- 6. Gatten Subdivision 2024 Replat**
 - KPB File 2023-136**
 - Segesser Surveys / Hill, Croom**
 - Location: Patty Avenue**
 - Sterling Area**

**ITEM #6 - PRELIMINARY PLAT
GATTEN SUBDIVISION 2024 REPLAT**

KPB File No.	2023-136
Plat Committee Meeting:	January 8, 2024
Applicant / Owner:	Glendale Croom of Sterling and Jon Hill of Sterling
Surveyor:	John Segesser / Segesser Surveys
General Location:	Patty Ave in Sterling AK

STAFF REPORT

Gatten Subdivision 2024 Replat

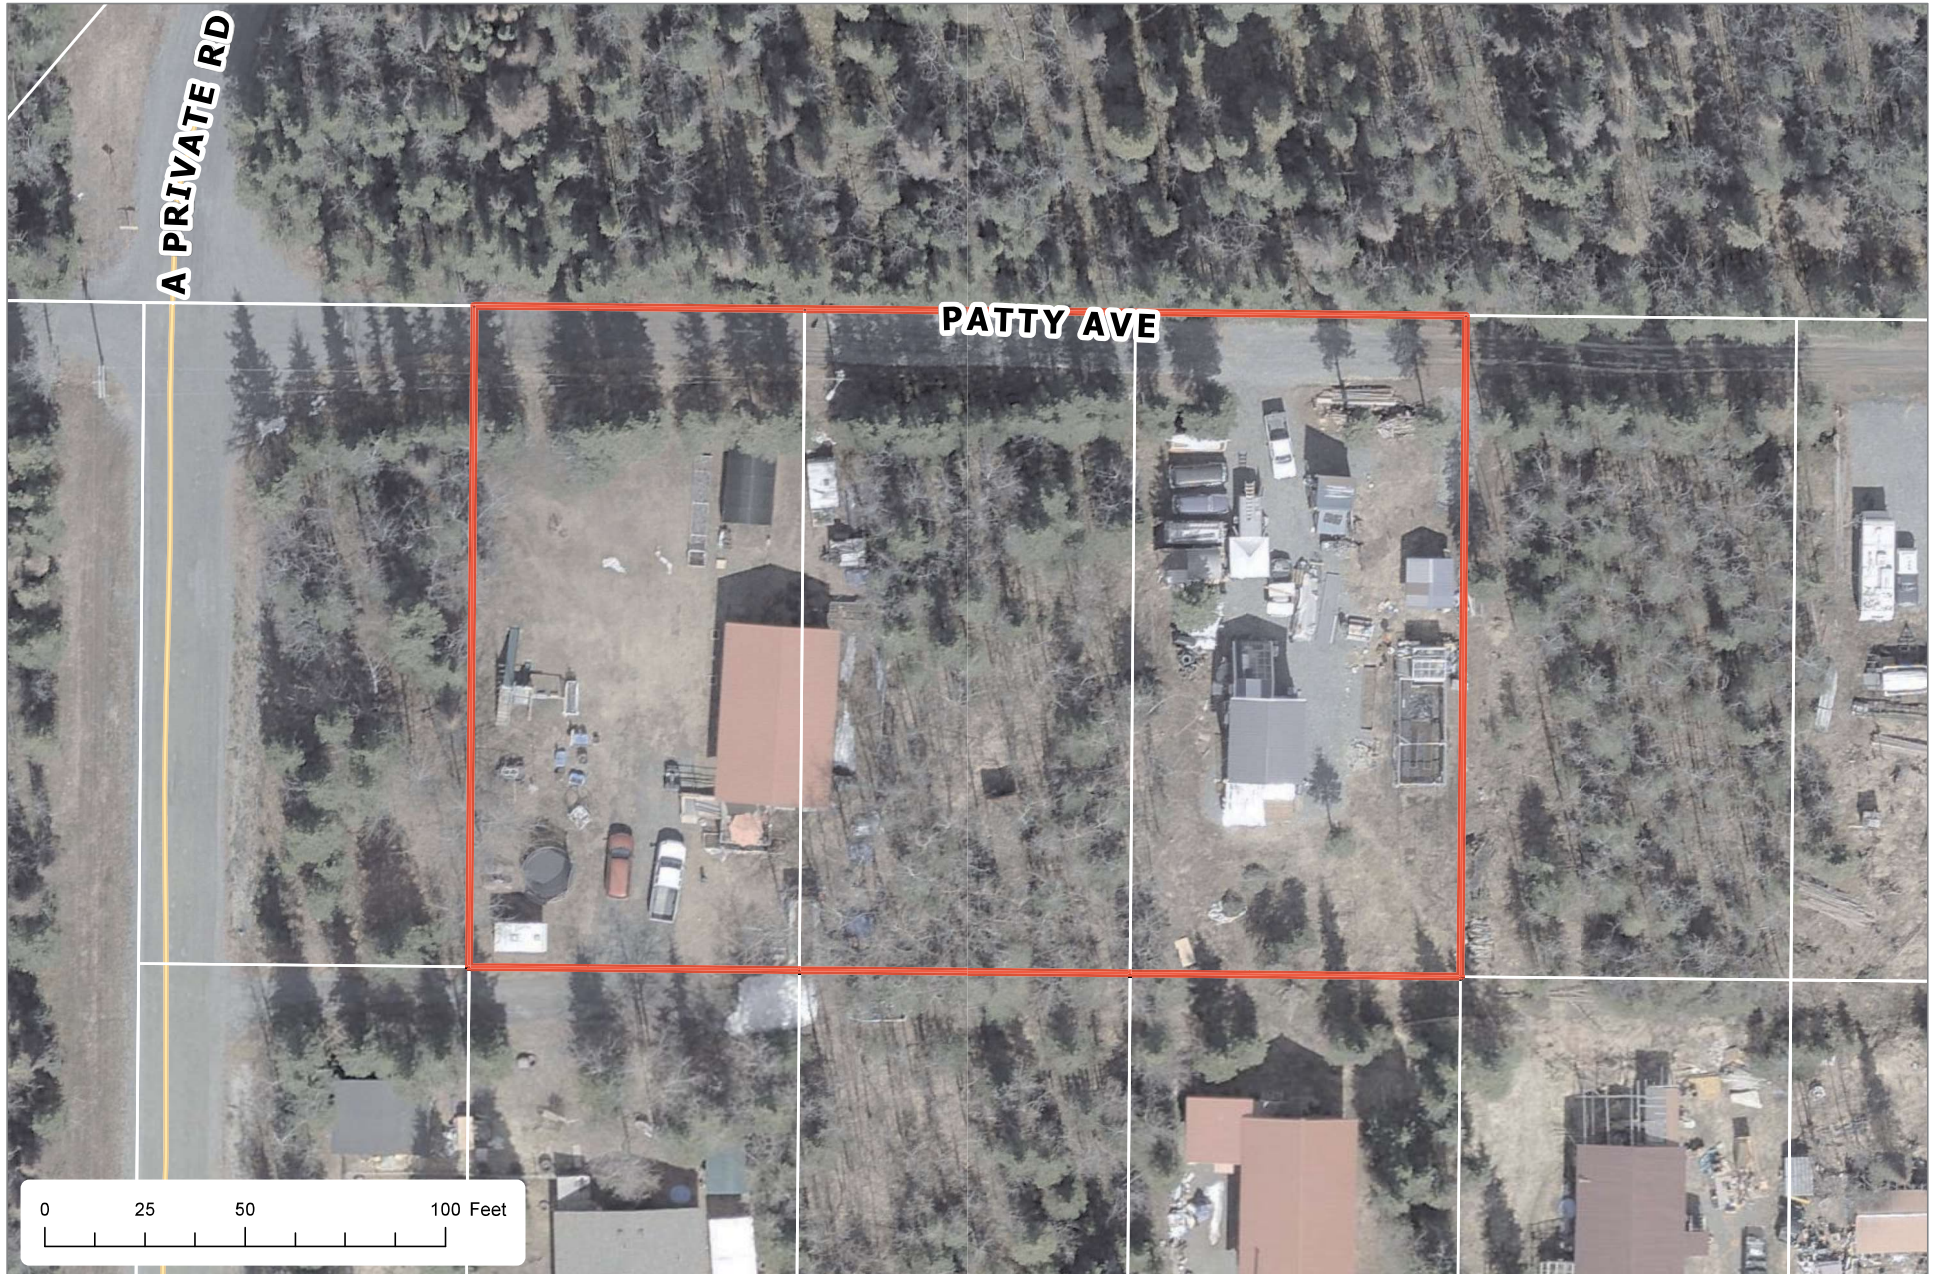
Add record dimensions to the drawing.

Add to KPB File No '2023-136'

Check spelling in the legal description

Show and label A Private Rd to the northwest.

Alley should be a 10' easement per K-995

Add Certificate of Acceptance to final

Add date of January 8, 2024 to Plat Approval

Tie the subdivision to closest BLM / GLO corner
